Motorola Mobility LLC.

Product Equality Declaration

The differences between EMEA DS and previous as below:

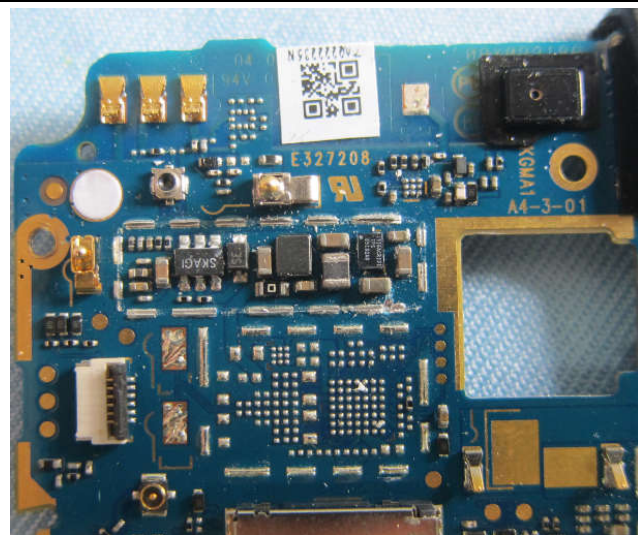
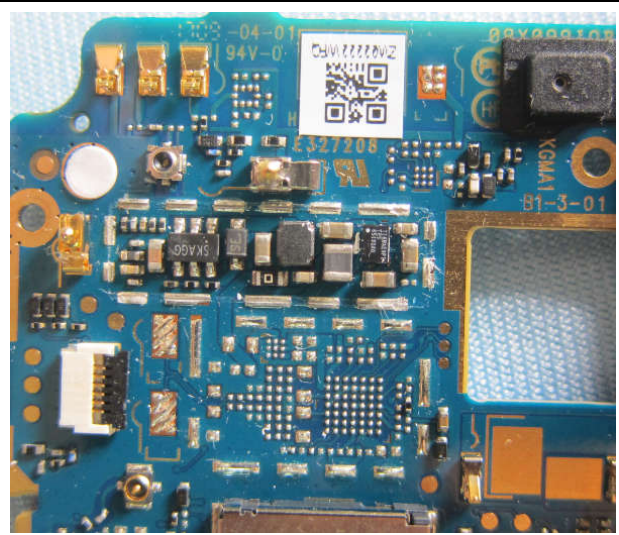
Previous: Manual to remove SAR Sensor Chip and SAR Sensor shrapnel;

Current: Optimizing the BOM patch and removing the Sar sensor and its matching circuits.

These changes have no effect on RF.
